ExG/COMP
Informal document 2 (2004)
24 February 2004

Informal ad hoc Expert Group on the
Computerization of the TIR procedure

Updates of the Reference Model of the TIR Procedure

Issue ExG/37 (1.1.3. Boundaries)

Figure 1.1 Stakeholders and actors

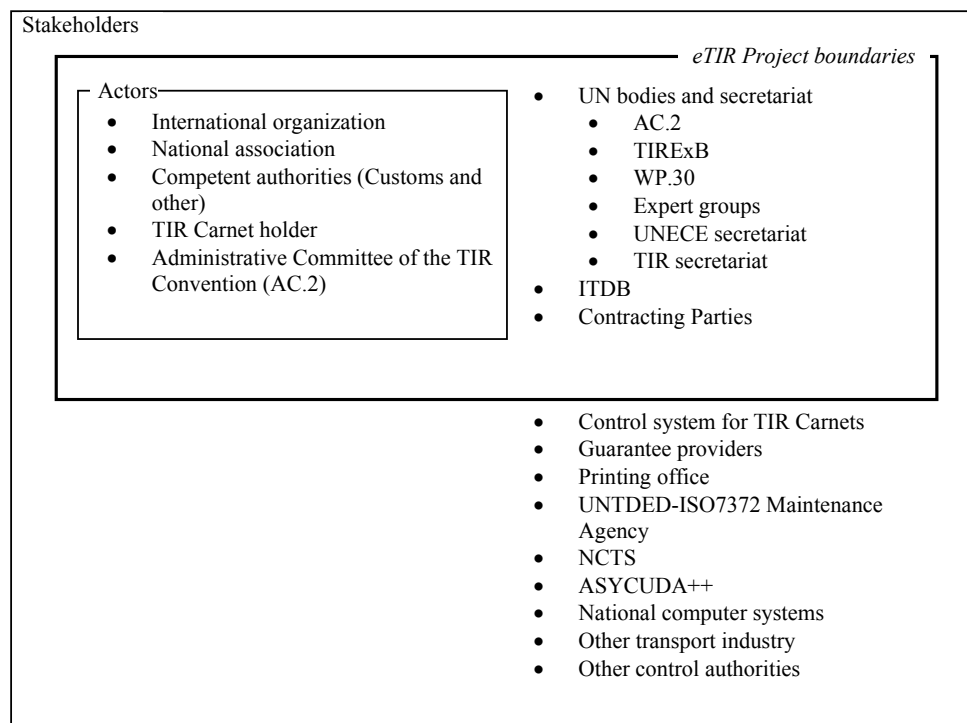
3. Therefore, the secretariat proposes to replace Figure 1.1 of Chapter 1.1.3. (boundaries) with the following figure (new issue, No.37).

5. Chapter 1.1.3. (Boundaries of the eTIR Project) of the Reference Model: replace Figure 1.1 by the following:

6. The Expert Group is requested to discuss, finalize and, possibly, validate Figure 1.1. as presented above.
